Access Compliance Report Public Rights-of-Way (Curb Ramps)

Main Street: **RODEO_DR** Cross Street: **PACIFIC_AVE** Location: **NE**

ADA ID: **RPRK210921181548** Ramp Type: **Type 1 - Perpendicular Diagonal Initial Pass/Fail: Pass** Overall Compliance: **No** Severity Score: **0**

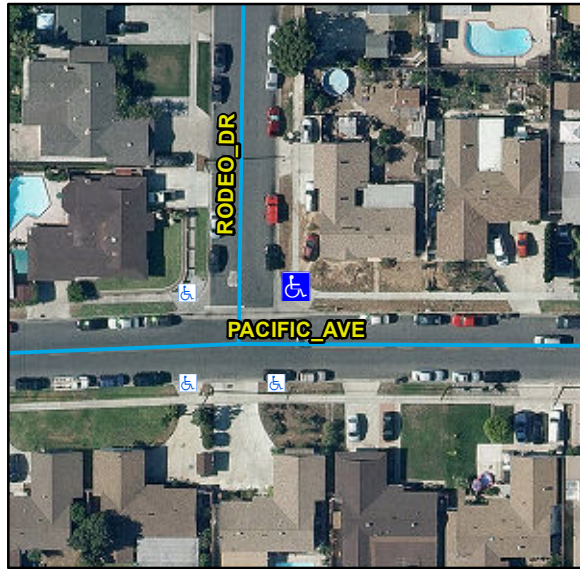
Compliance	Description	Data	Compliance	Description	Data
N/A	Ramp Length (in)	77	N/A	Flare Type LT	
Yes	Ramp Width (in)	48			Sloped
Yes	Ramp Run Slope (%)	6.7	N/A	Flare Slope LT (%)	4.3
Yes	Ramp Cross Slope (%)	0.4	N/A	Flare Traversable LT	No
N/A	Landing Present	Yes	N/A	Flare Type RT	
N/A	Landing Length (in)	48			Sloped
Yes	Landing Width (in)	48	N/A	Flare Slope RT (%)	4
Yes	Landing Run Slope (%)	1.5	N/A	Flare Traversable RT	No
Yes	Landing Cross Slope (%)	0.1	Yes	DWS Provided	Yes
N/A	Landing Movement Obstructed?	Yes	Yes	DWS Contrast	Yes
	Landing Movement Type	Curb	Yes	DWS Length (in)	36
N/A	Landing Shared	No	Yes	DWS Full Width	Yes
N/A	Clear Space	Yes	Yes	DWS Offset Left (in)	0
N/A	Clear Space To Crosswalk (in)	48	Yes	DWS Offset Right (in)	N/A
N/A	Marked Crosswalk 1	No	N/A	Marked Crosswalk 2	No
	Crossing 1 Direction	W		Crossing 2 Direction	S
	Marked Crosswalk 1 Width (in)	N/A		Marked Crosswalk 2 Width (in)	N/A

N/A	Ramp Inside Crosswalk 1	N/A	Yes	Ramp Inside Crosswalk 2	N/A
	Crossing 1 Slope (%)	2.5		Crossing 2 Slope (%)	4.3
	Crossing 1 Cross Slope (%)	0.6		Crossing 2 Cross Slope (%)	0.4
Yes	Gutter Ponding	No	Yes	Curb Slope	3.8
Yes	Gutter Lip Height (in)	0		Road Run Slope (%)	0.1
Yes	Gutter Run Slope (%)	0.6		Road Cross Slope (%)	3
No	Gutter Cross Slope (%)	3.3			
Yes	Overall Surface Condition: Acceptable		Yes	Perp Joint Present	Yes
	Cross Gutter Present?	Yes		Spandrel Present?	Yes
	Replace Cross Gutter?	No		Replace Spandrel?	No

Remove & Replace Landing. Remove & Replace Gutter.

R304.2.1, R304.5.3, STD 1115
